Our Ref: R/2022/27
File No: 2022/611104
Your Ref: SSD-35962232

Advice on Environmental Impact Statement – Burrows Road Multi-Level Warehouse – 1-3 Burrows Road, St Peters

Figure 1: Appendix X Stormwater drainage plan (bioretention devices in yellow)

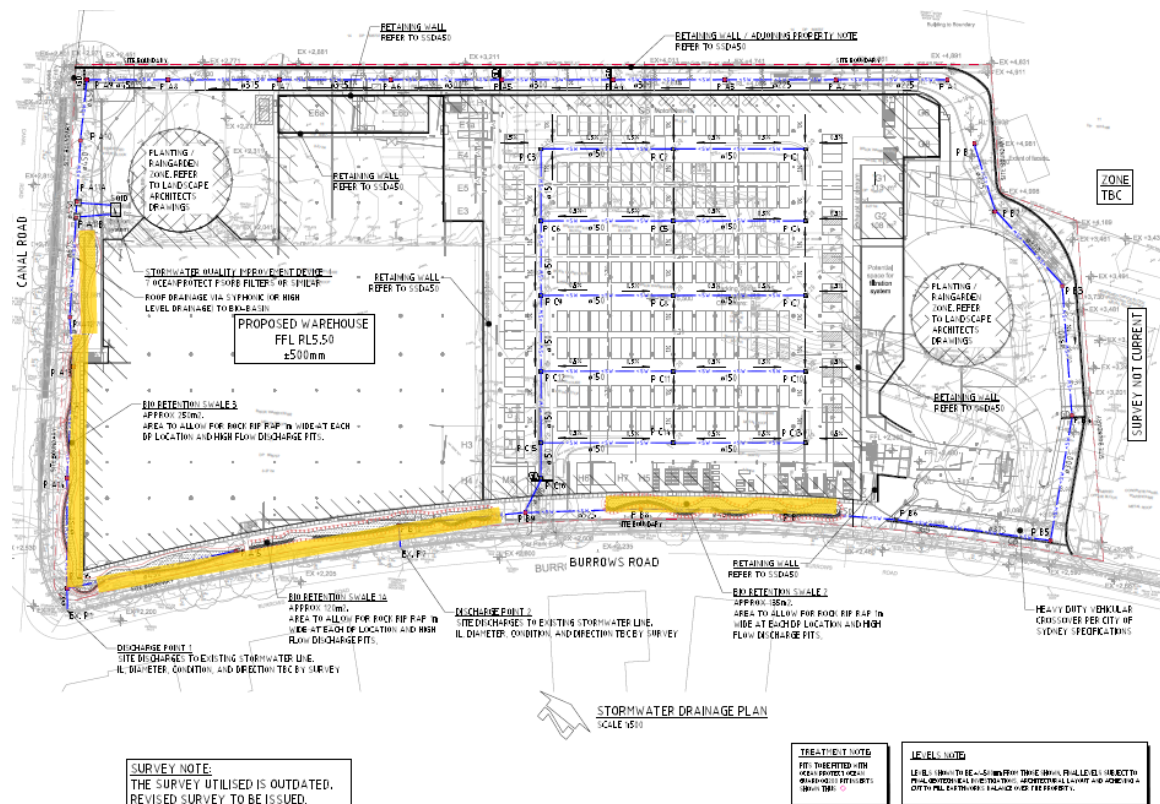
A review of the civil plans indicate the 6 metre landscape setback is significantly impeded by stormwater pits and 450mm diameter pipes, as well as three long curved 1

metre wide bioretention swales lined with rock rip rap. The bioretention swales are 120 to 135m long on Burrows Road and up to 250m long on Canal Road (Fig 1 below).

- It is unclear whether the 500mm depth bioretention soil filter media detailed by the engineer needs to be removed and replaced in the future to maintain effectiveness as a drainage device.
- Whether the civil design considers remediation of site contamination in the landscape setback.
- It is unclear if the stormwater design has been coordinated with the landscape design and tree placement and if there is adequate soil volume to support the trees to maturity.

The applicant is requested to submit an engineer's report to clarify the design and requirements including remediation. The City also requests landscape plans at a legible scale, black and white that clearly demonstrate coordination and resolution of the landscape setback, location of trees, levels (IL, RL, TW) and confirm the permeable pavement specification and detail.
